AGENDA

President and Board of Trustees
Village of Arlington Heights
Board Room
Arlington Heights Village Hall
33 S. Arlington Heights Road
Arlington Heights, IL 60005
October 17, 2016
8:00 PM

Mr. Sam Hubbard
PC Project #16-020
STR Project # 16047
September 21, 2016
Page 10 of 10

THOMAS MIDDLE SCHOOL ADDITION AND RENOVATIONS

CX1.1

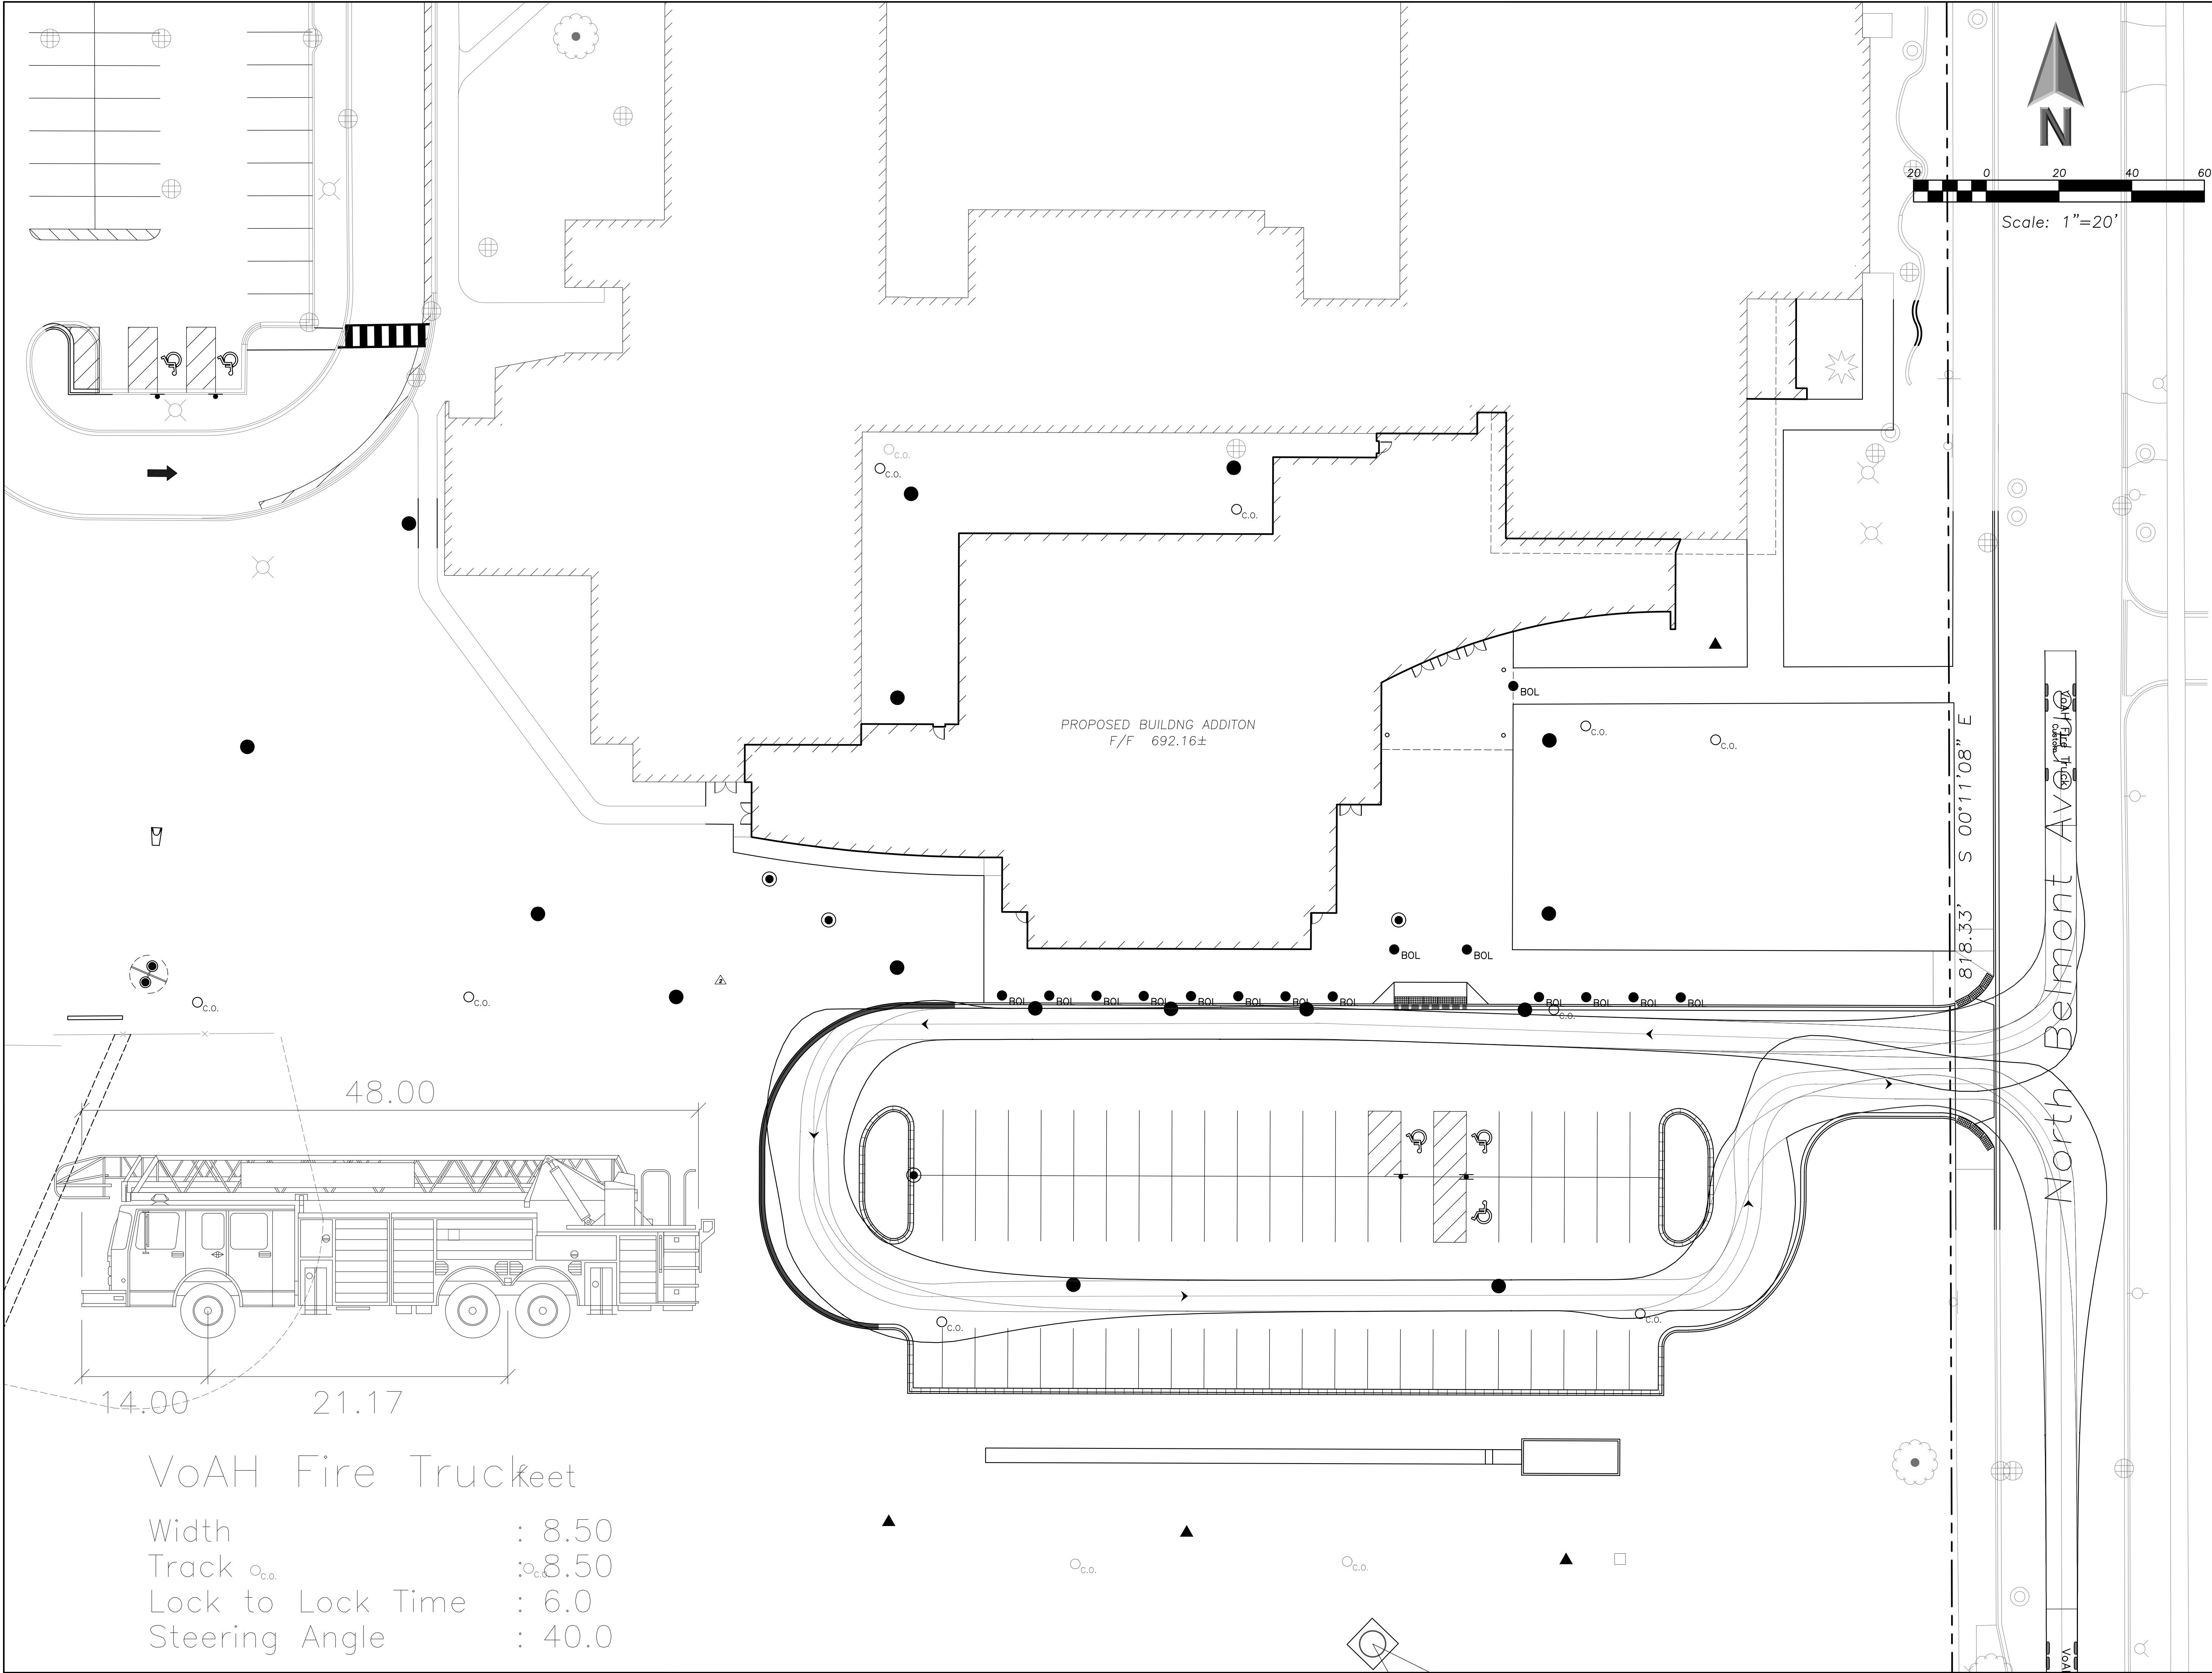
21. Sheet CX2.1: Show the extent of the front and rear overhangs for the fire vehicle. Remove the bus lines from this exhibit, since there is a separate exhibit for the bus.

Sheet No:
CX2.2

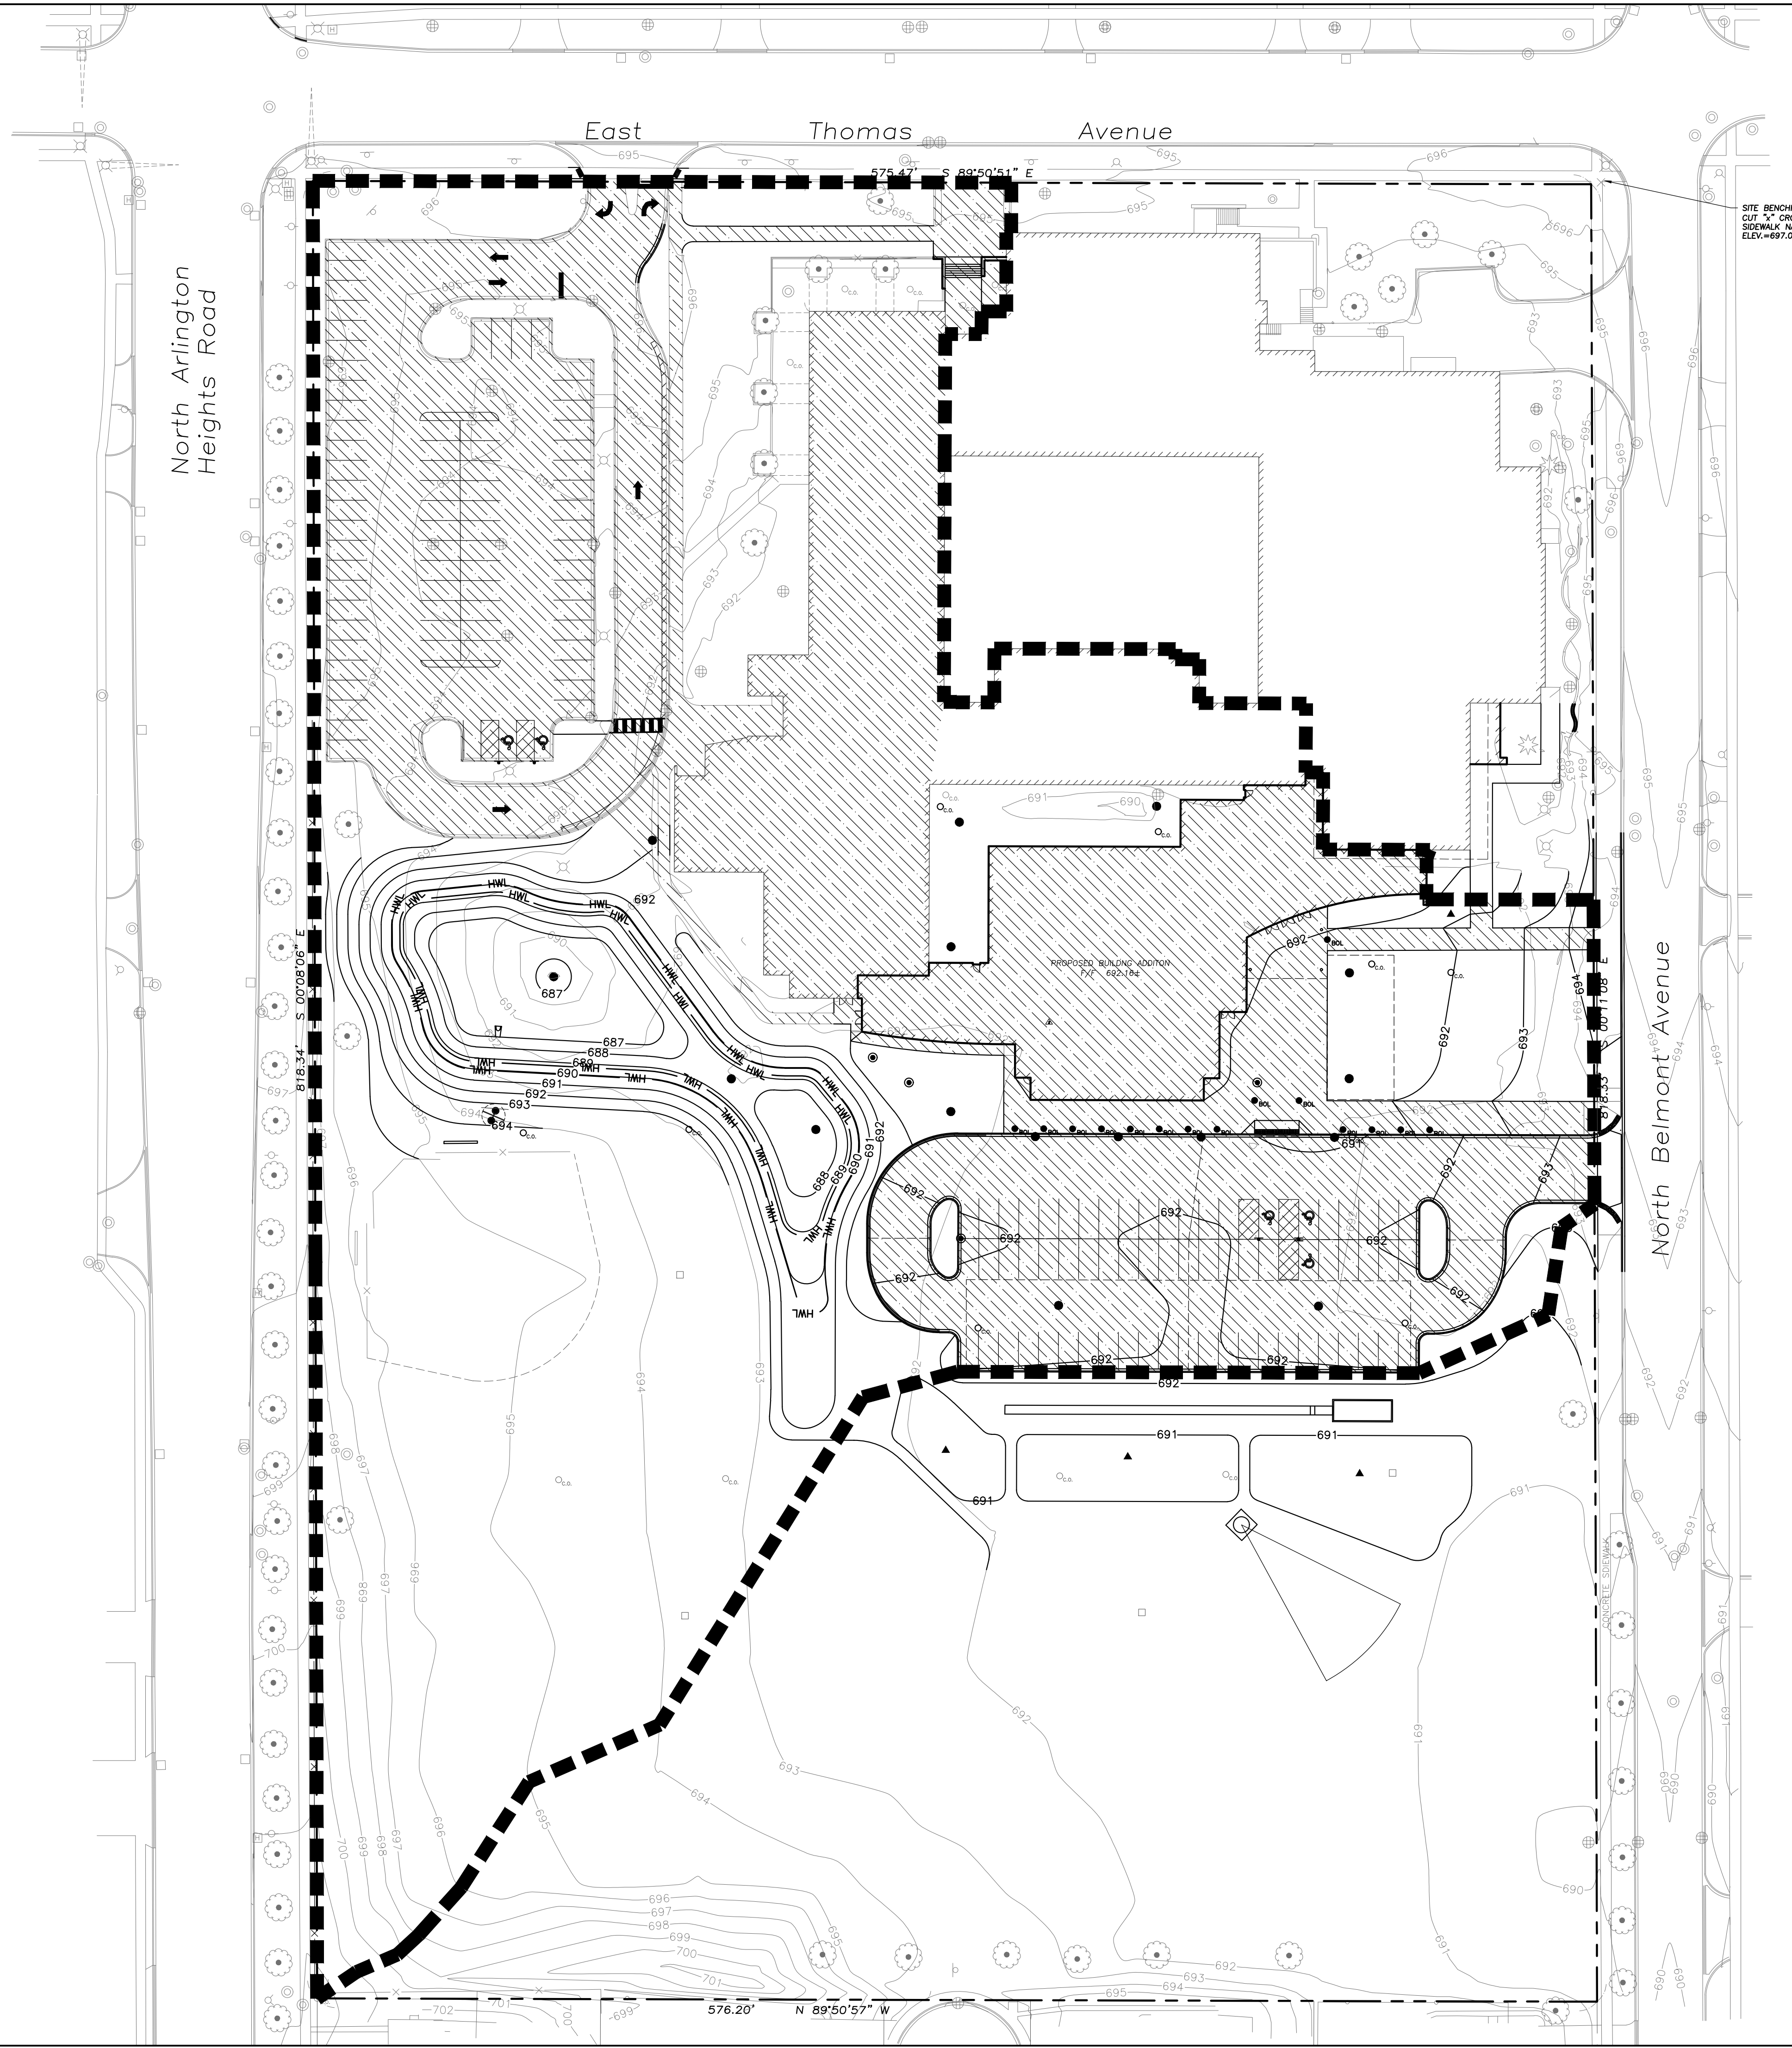
22. Sheet CX2.2: Show the extent of the front and rear overhangs of the bus.
